Access Compliance Report

Public Rights-of-Way

(Curb Ramps)

Intersection ID: 48771	Main Street: LUMBER_LN	Cross Street: TURNING_WHEEL_DR	Location: SW
ADA ID: 23FF93F96CBF	Ramp Type: PerpDiag	Initial Pass/Fail: Fail	Overall Compliance: No
		Severity Score: 10

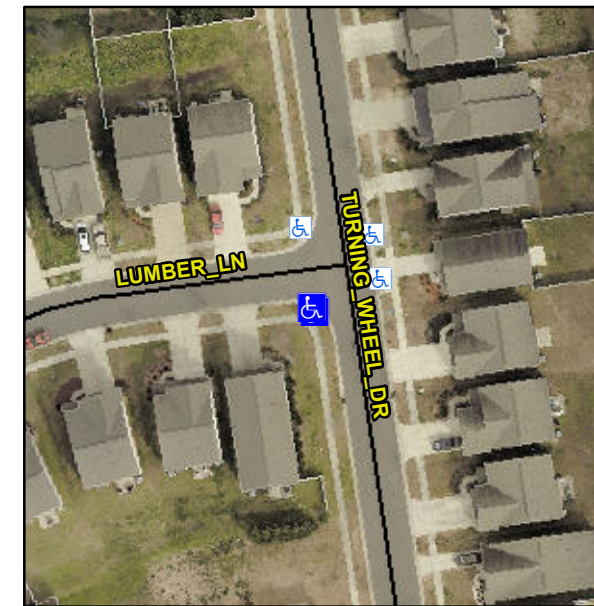
R304.5.1, R304.5.3

Compliance	Description	Data	Compliance	Description	Data
N/A	Ramp Length (in)	74.0	Yes	Ramp Slope (%)	5.4
No	Ramp Width (in)	47.0	No	Ramp XSlope (%)	4.2
N/A	Flare Type LT	N/A	N/A	Flare Type RT	N/A
N/A	Flare Slope LT (%)	N/A	N/A	Flare Slope RT (%)	N/A
N/A	Flare Traversable LT?	N/A	N/A	Flare Traversable RT?	N/A
N/A	Landing Length (in)	N/A	N/A	DWS Provided?	N/A
N/A	Landing Width (in)	N/A	N/A	DWS Contrast?	N/A
N/A	Landing Slope (%)	N/A	N/A	DWS Length (in)	N/A
N/A	Landing X Slope (%)	N/A	N/A	DWS Full Width?	N/A
N/A	Landing Curb? (Y/N)	N/A	N/A	DWS Offset (in)	N/A
N/A	Shared Landing?	N/A			
N/A	Gutter Ponding?	N/A	N/A	Gutter Slope (%)	N/A
N/A	Gutter Lip Ht (in)	N/A	N/A	Gutter X Slope (%)	N/A
N/A	Painted X Walk1?	No	N/A	Painted X Walk2?	No
	X Walk 1 Direction	To E		X Walk 2 Direction	To N
N/A	X Walk 1 Width (in)	N/A	N/A	X Walk 2 Width (in)	N/A
	X Walk 1 Slope (%)	5.4		X Walk 2 Slope (%)	1.6
	X Walk 1 X Slope (%)	1.3		X Walk 2 X Slope (%)	4.4

Remove & Replace Curb Ramp With Two New Directional Ramps or Equivalent.
